# Product Change Notice (PCN)

PCN Number: **PCN-0451091R-01**

Product(s) Affected: *PJ-043-SMT-TR*

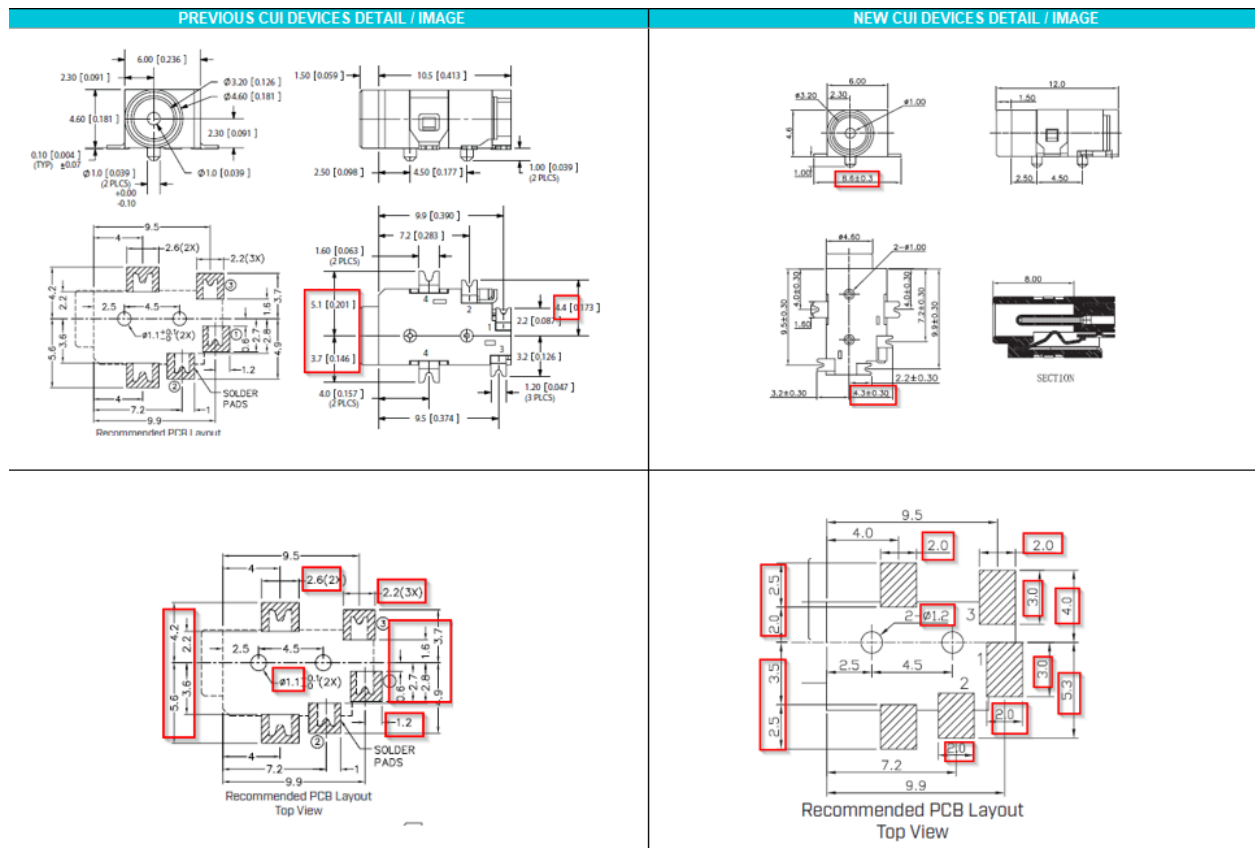
Description of Change: *Minor Housing and footprint differences. Material Change on the housing and terminals. See image Below*

PREVIOUS CUI DEVICES DETAIL / IMAGE			NEW CUI DEVICES DETAIL / IMAGE		
	MATERIAL	PLATING	DESCRIPTION	MATERIAL	PLATING/COLOR
center pin	brass	silver	center pin	brass	tin
terminal 1	brass	silver	terminal 1	brass t-0.25	tin
terminal 2	copper alloy	silver	terminal 2	SUS301 t-0.25	tin
terminal 3	brass	silver	terminal 3	brass t-0.25	tin
shield	cold rolled steel	nickel	shield	brass t-0.25	tin
plastic	PA6T or equivalent		housing	PA9T (UL94V-0)	black
